Value Engineering Study Report – Final

I-69 Ohio River Crossing Project Evansville, IN and Henderson, KY

August 2, 2019

Idea Title	Build a four-lane (two lanes in each direction) bridge (I-69) with minimum width shoulders
Function	Support Redundancy

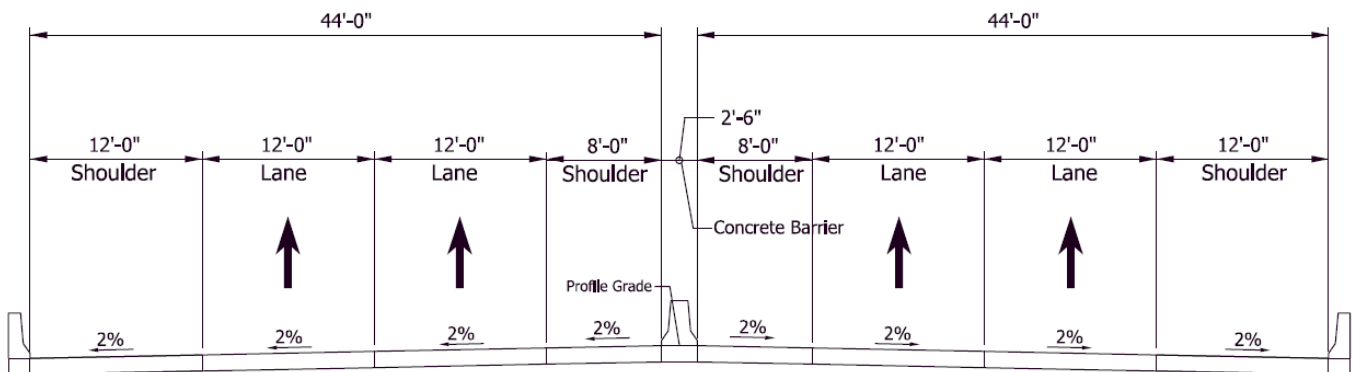
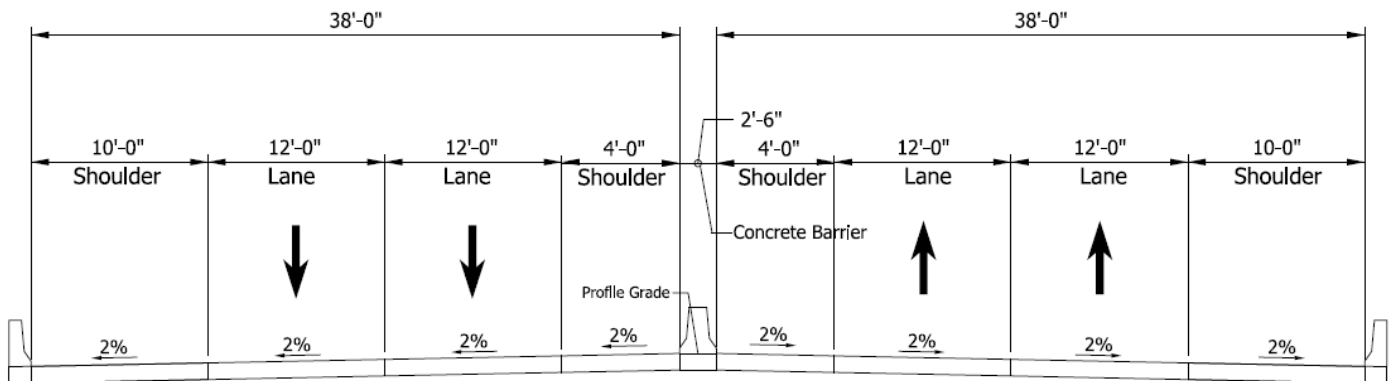
The reduction of the shoulder width to AASHTO minimum allowable meets design standards and will reduce the overall cost of an expensive project component.

The VE team does not recommend further reduction of the shoulder widths beyond the alternative concept because of the challenges with maintenance of traffic for future bridge widening, and the concerns with lane reduction on the bridge during emergency situations. The VE team does not recommend that the design team pursue a design exception to further reduce the shoulder width; the spacing of the adjacent interchanges (~5 miles) is too substantial to allow alternate travel routes during emergency/maintenance scenarios.

During the design of the new I-69 bridge, consideration should be given to potential future expansion of the bridge. The need for expansion could result from either the need to take the remaining US 41 bridge out of service or demand for travel on I-69 that exceeds the capacity of the proposed 4-lane structure.

Idea Title	Remove US 60 interchange
Function	Support Redundancy

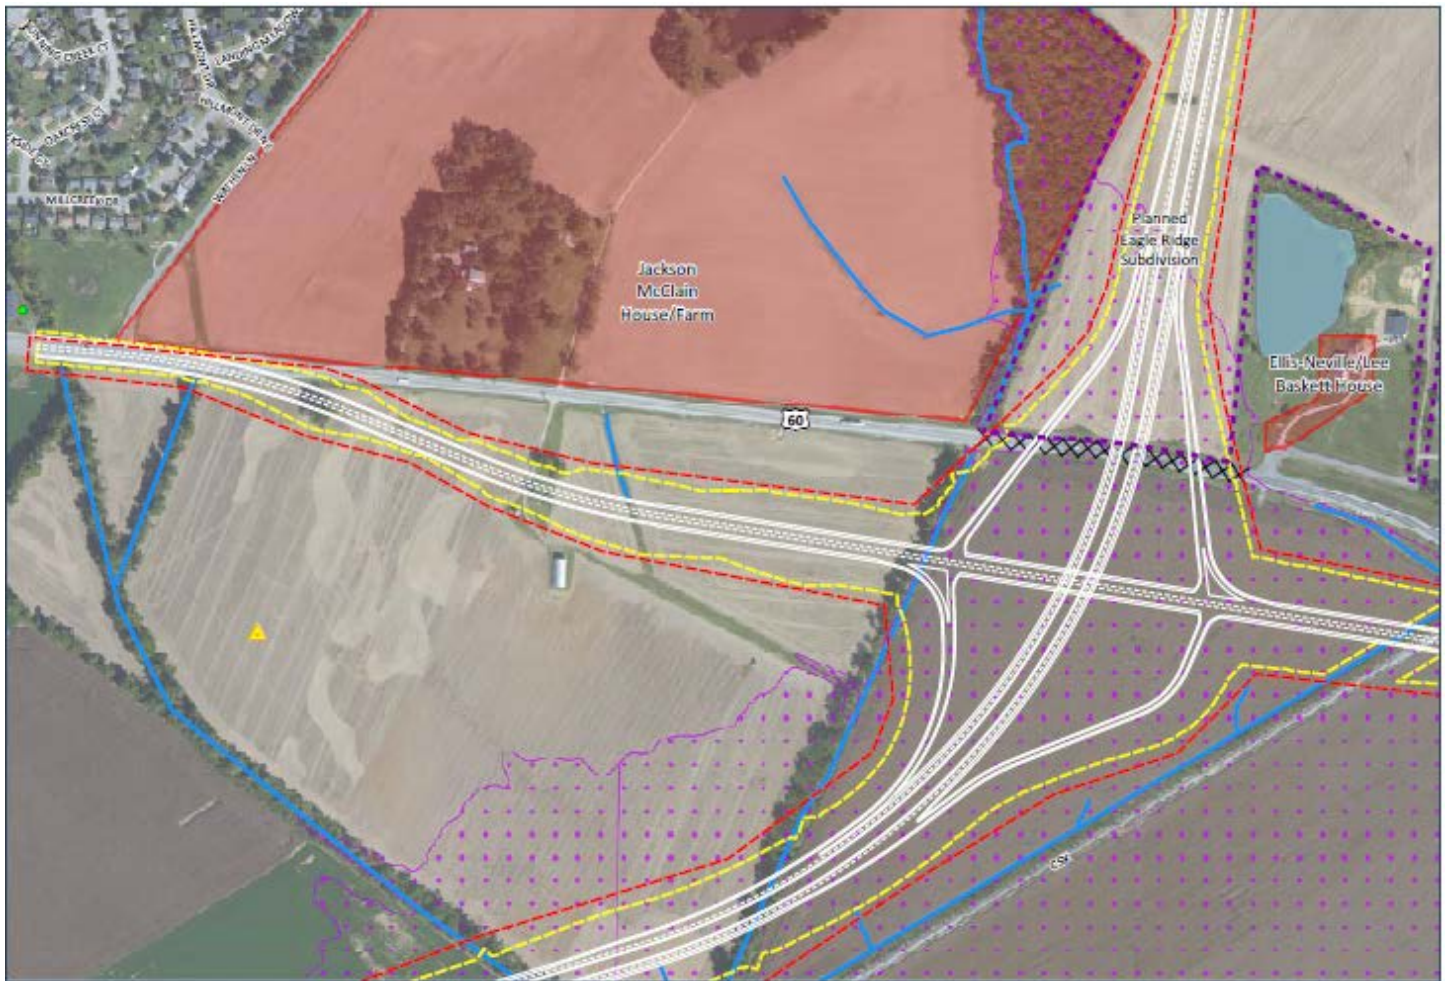
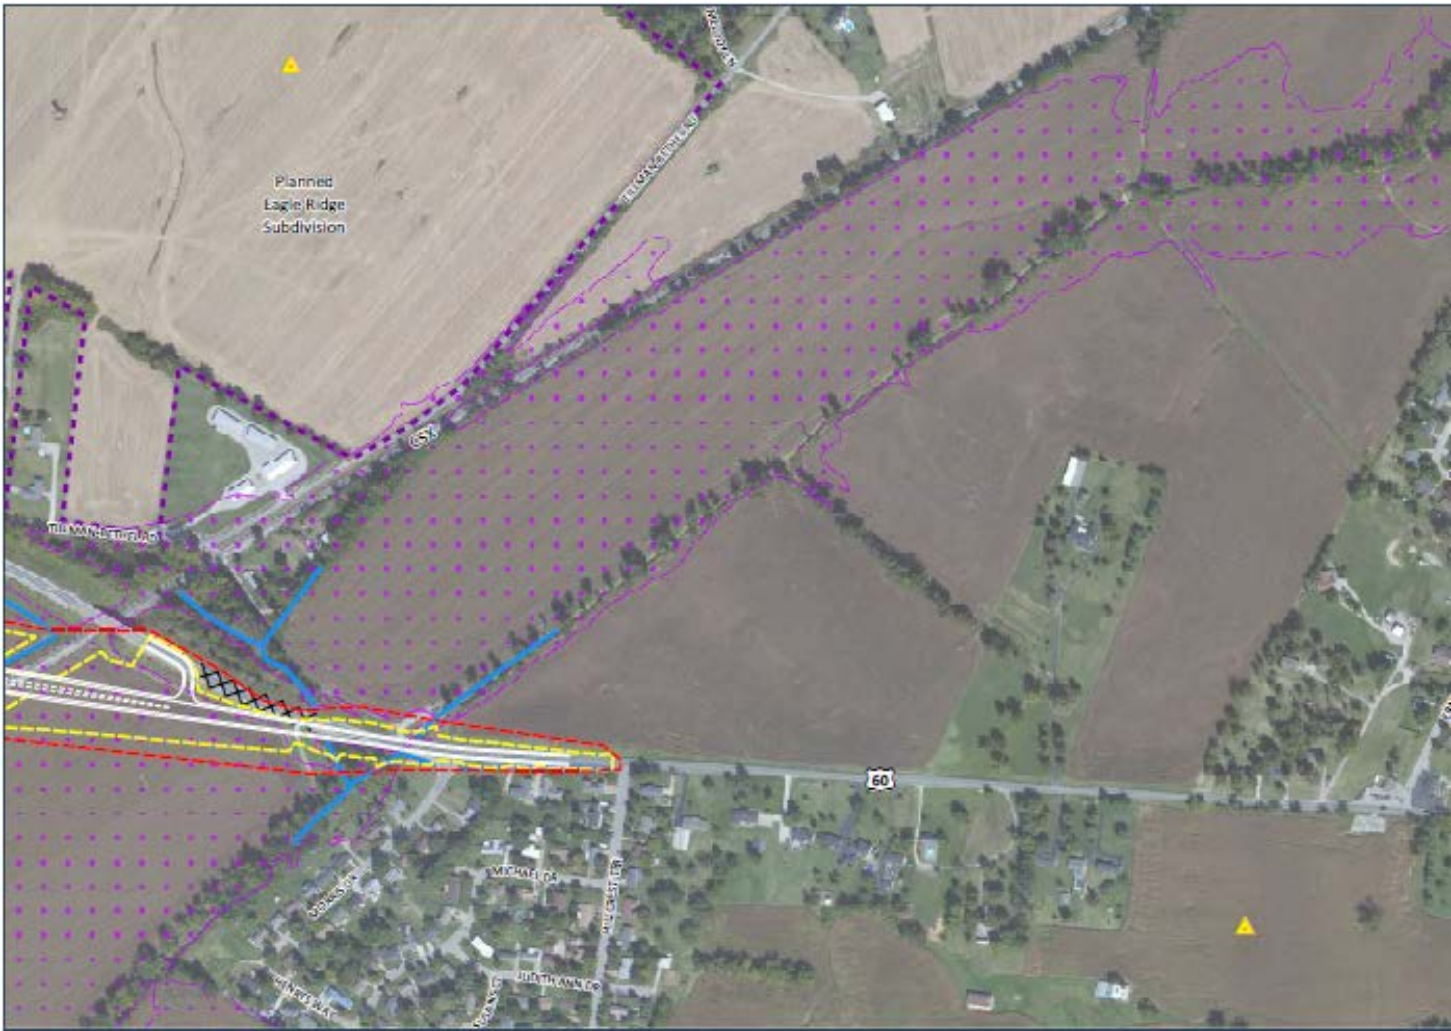
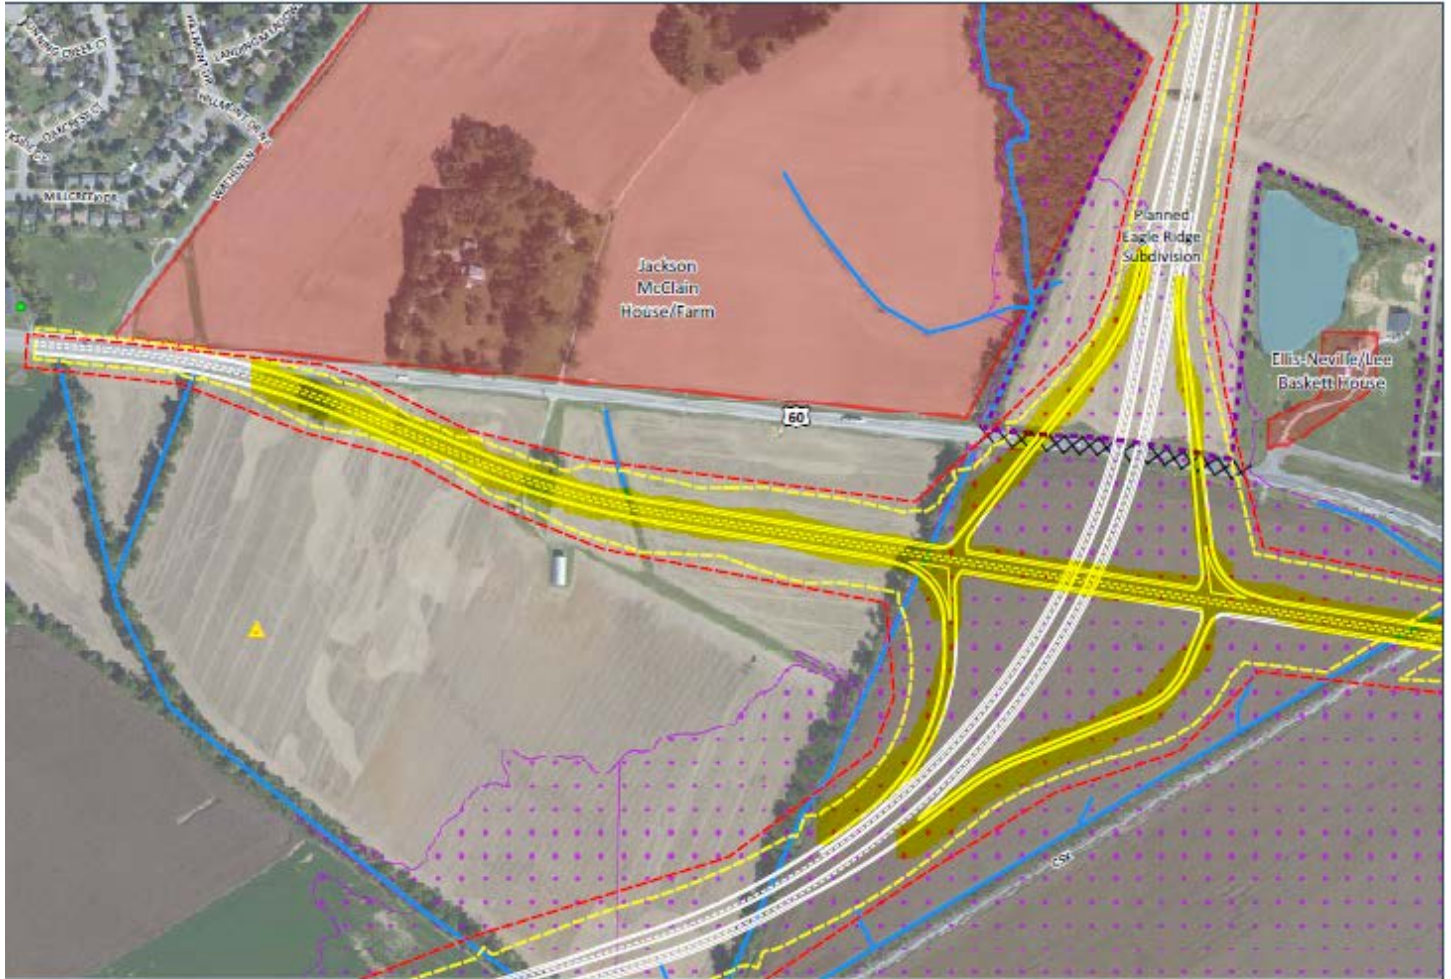
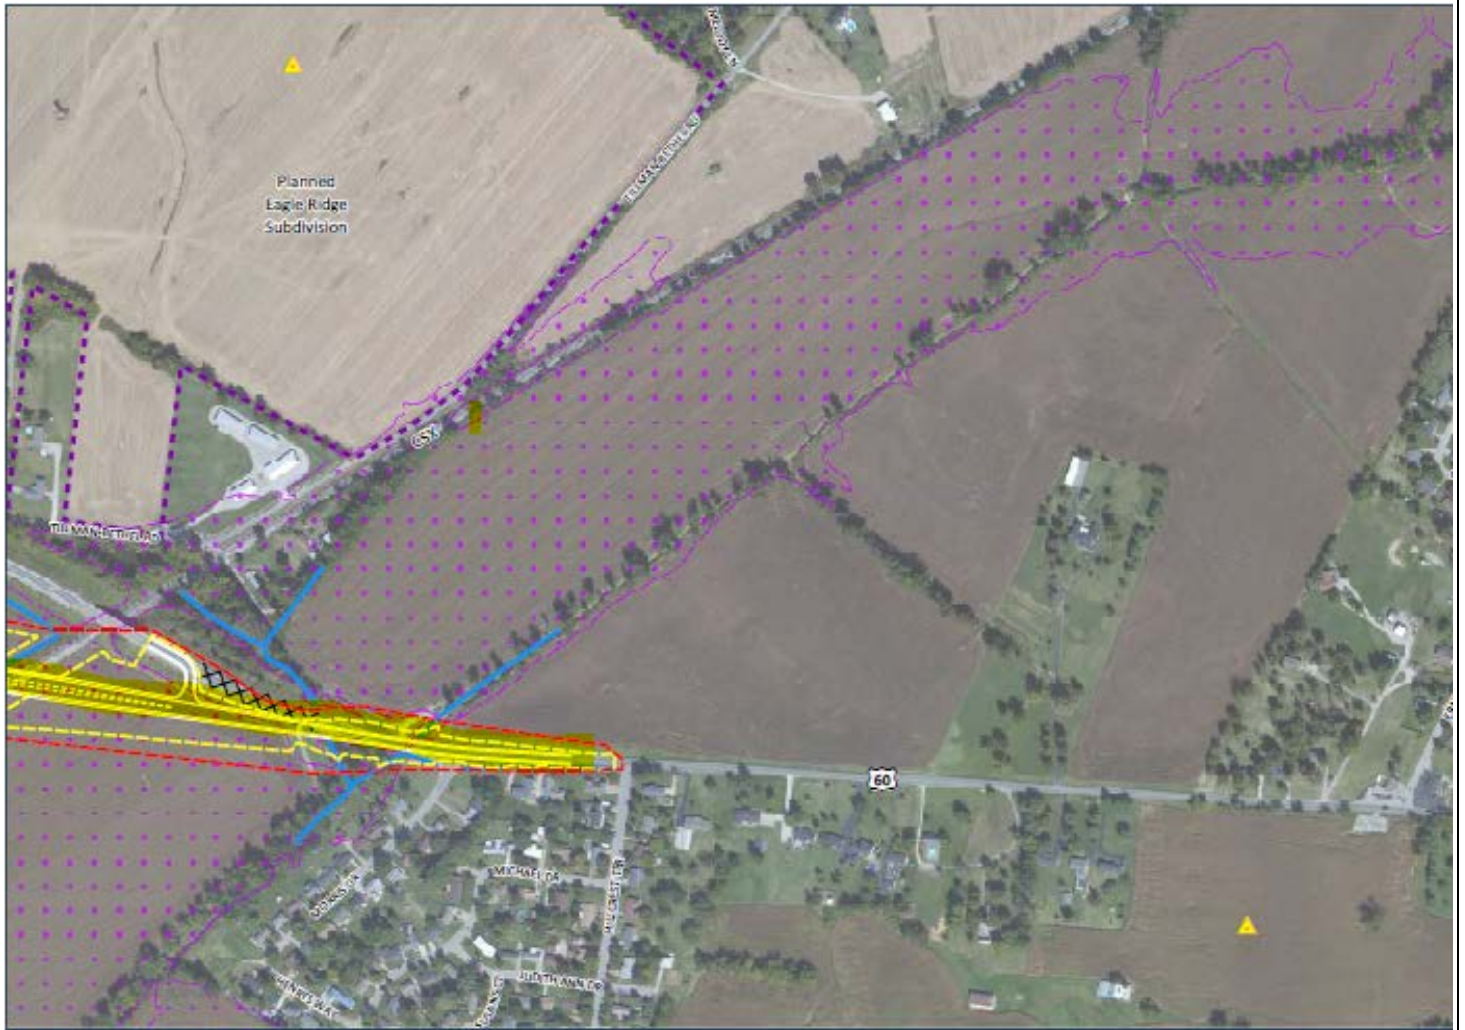
Eliminate construction of interchange with US 60 in Kentucky. Build I-69 overpass of US 60. Leave US 60 current alignment unchanged. Allow design of overpass for future interchange construction. This alternate reduces impact to historical properties, reduces right-of-way requirements, reduces cost, and eliminates inconvenience to traffic on US 60. This interchange does not add to the true purpose of the project and clearly eliminating it would save significant money. Impact to growth is minimal, as no development currently exists in the area and future projections show a population decline for Henderson.

This alternate design reduces impact to historical properties and therefore reducing the need for any special waivers, design exceptions, etc.

Proposed construction deletion

Idea Title	Remove US 41 Interchange
Function	Support Redundancy

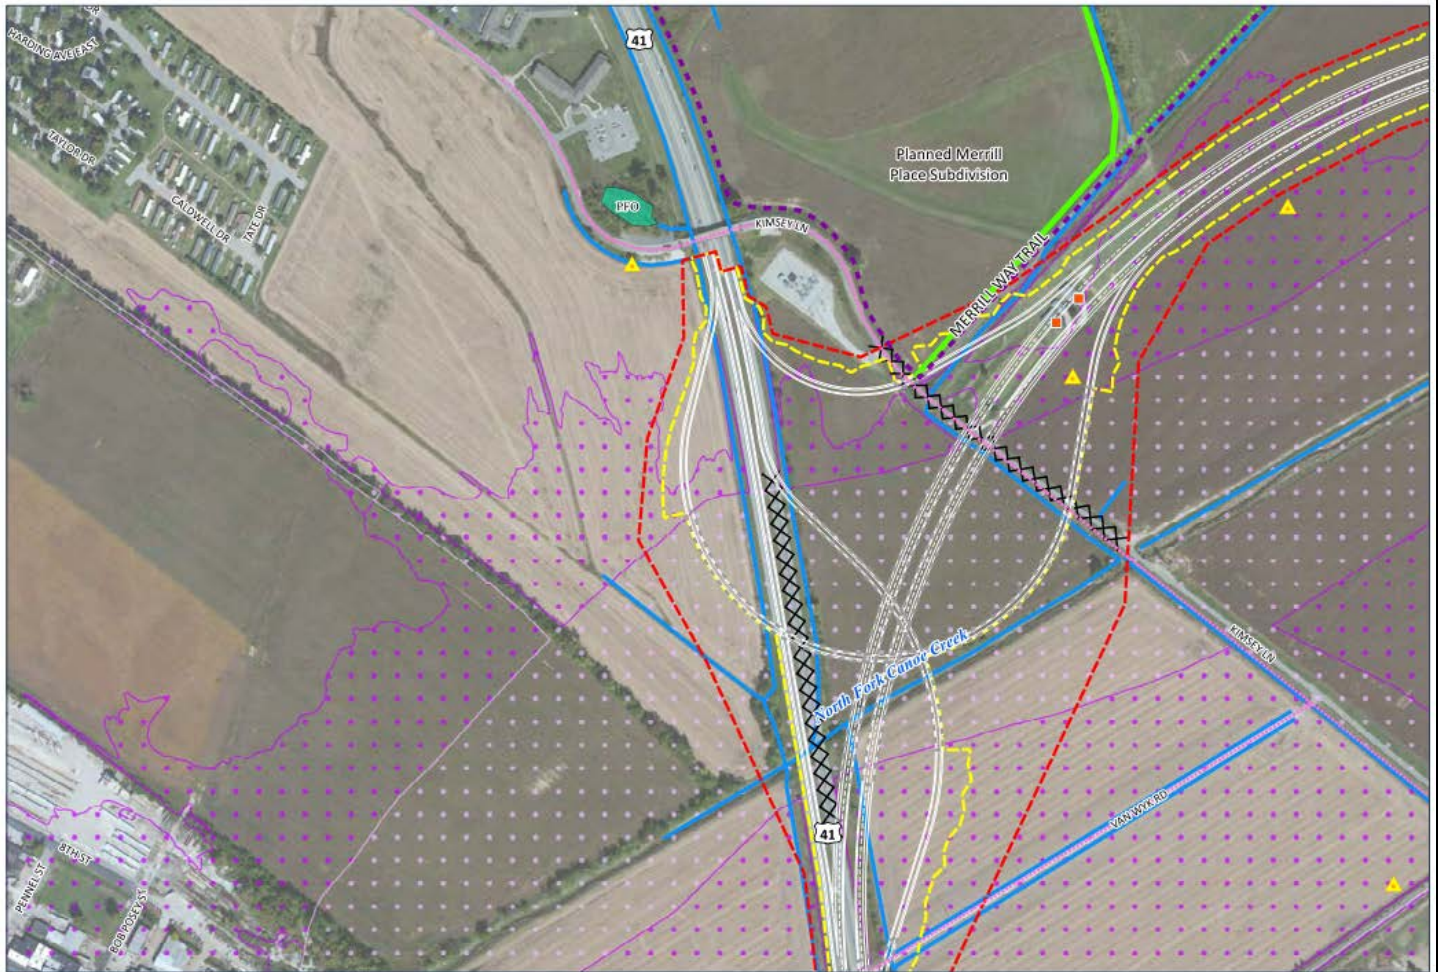
Connecting northbound I-69 to northbound US 41 may make it more acceptable to the public.
